BEFORE THE STATE OF FLORIDA
DEPARTMENT OF ENVIRONMENTAL PROTECTION

| BIG BEND STATION UNIT 4 |) | |
| MODIFICATION OF CONDITIONS |) | DEP CASE NO. PA 79-12D |

**FINAL ORDER MODIFYING
CONDITIONS OF CERTIFICATION**

FIGURE 1

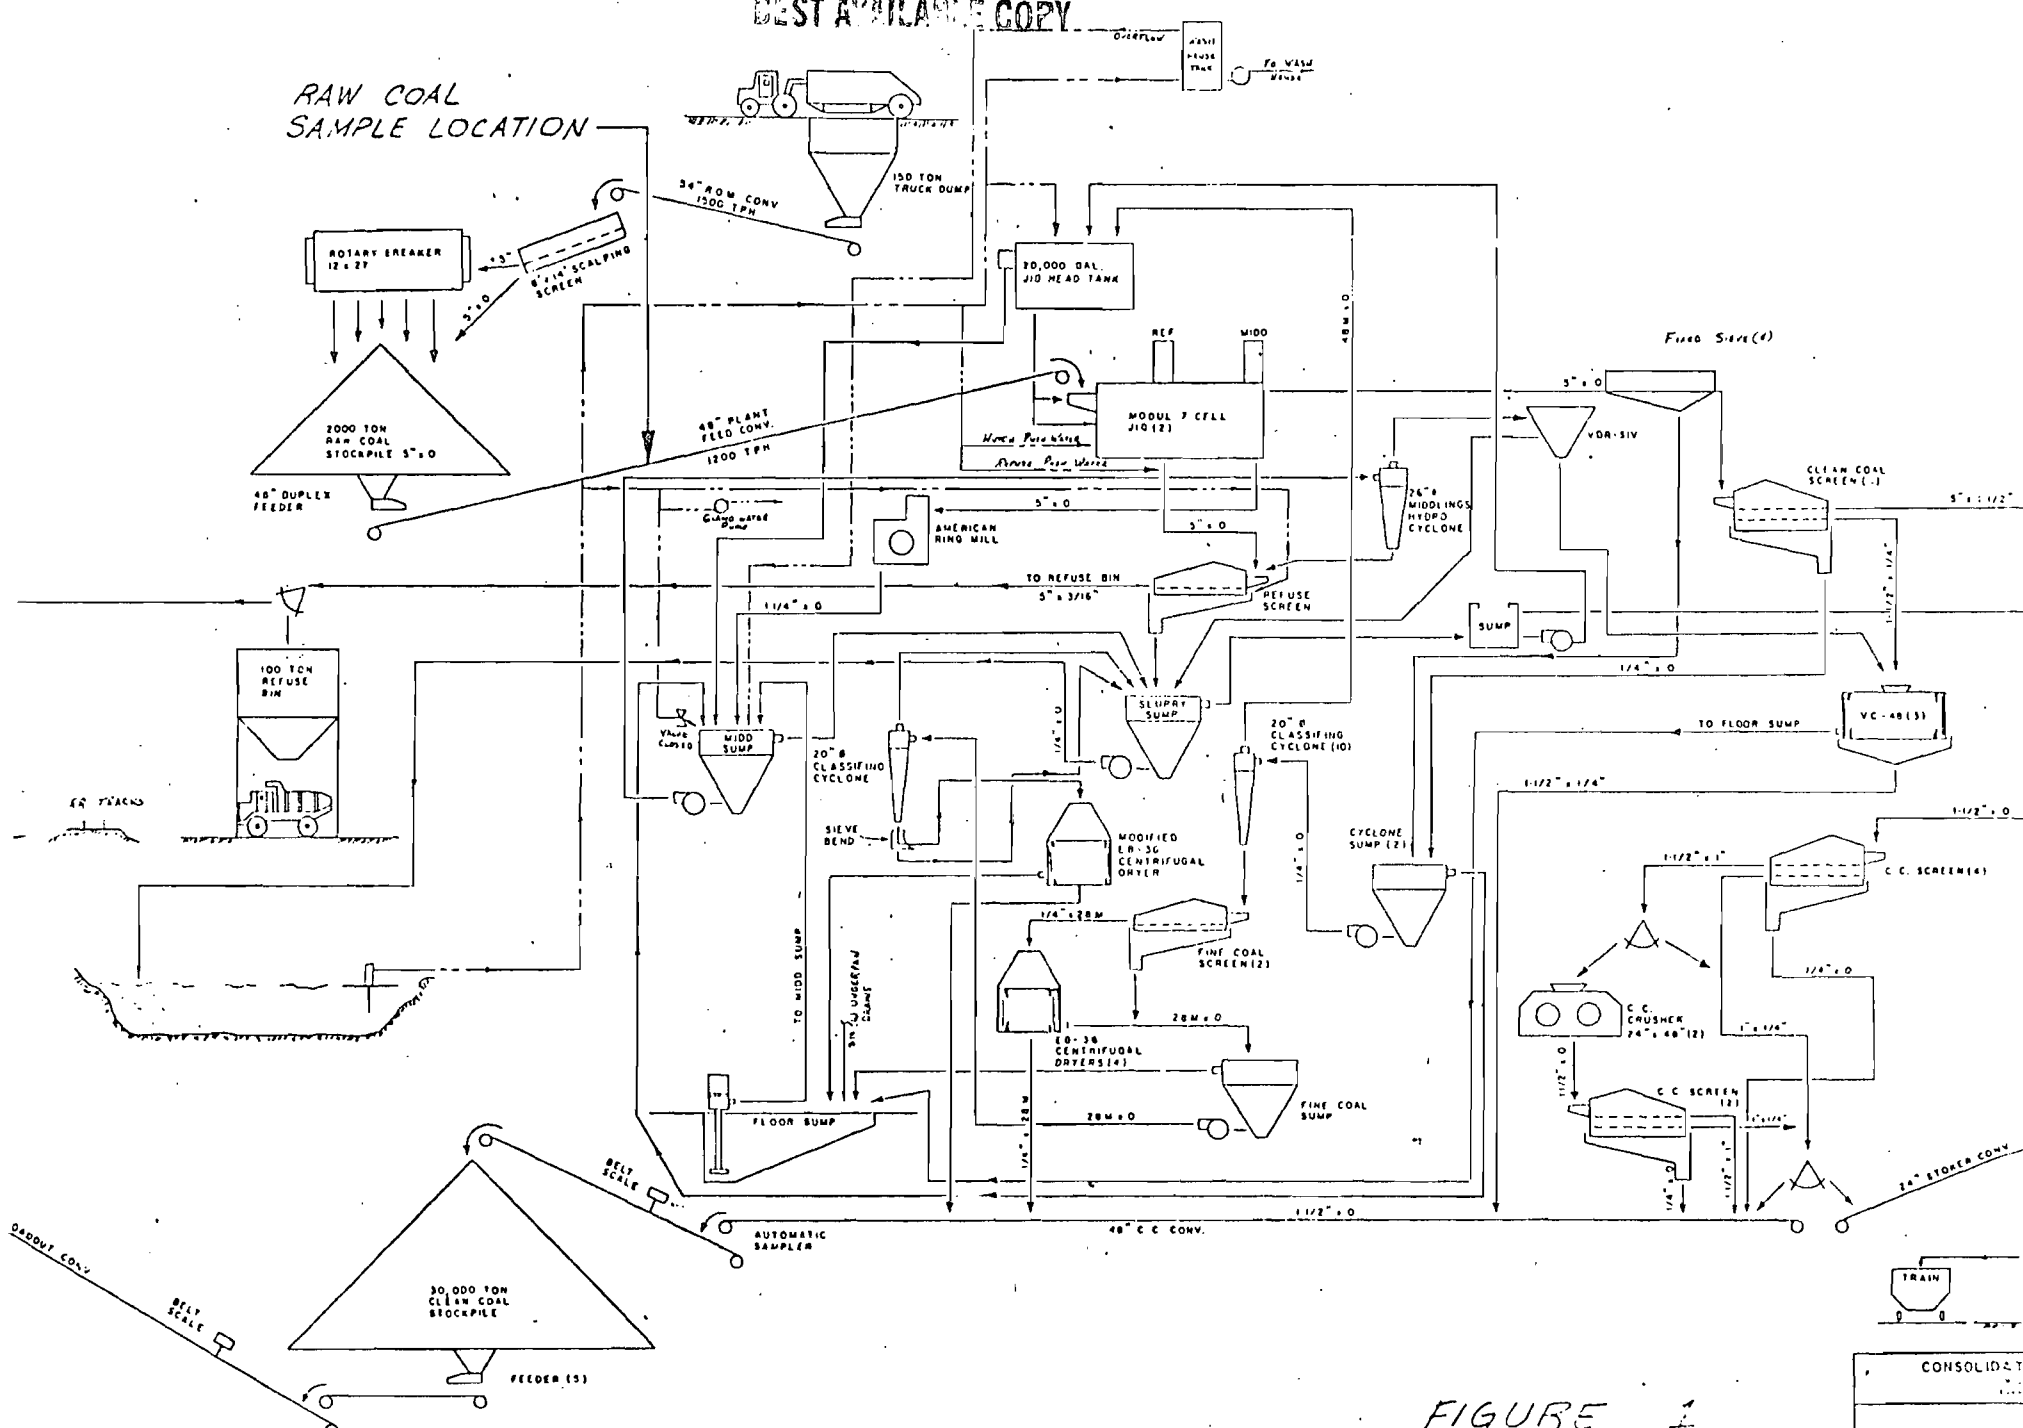
The department, in consultation with EPA (see attachment), has reviewed your December 23, 1985, request for approval of an alternate raw-coal sampling procedure to be used by Consolidated Coal Company. We agree that the proposed procedure is very similar to the one already approved for use by the Ziegler and Peabody coal companies. Therefore, by this letter, the department approves your request provided the following conditions are met:

1. The supplier shall stop and sample the raw coal conveyor belt at least once per day when coal is being washed for Tampa Electric Company.
2. The daily stop time shall be randomly selected.
3. The sample shall consist of a block section of raw coal of 15 inches in length by the entire width of the belt, taken at the location shown in Figure 1.
4. The sample processing and analysis shall be performed as described in Method 19, 40 CFR 60, Appendix A.
5. Calculation of weighted averages shall be made for all mines.
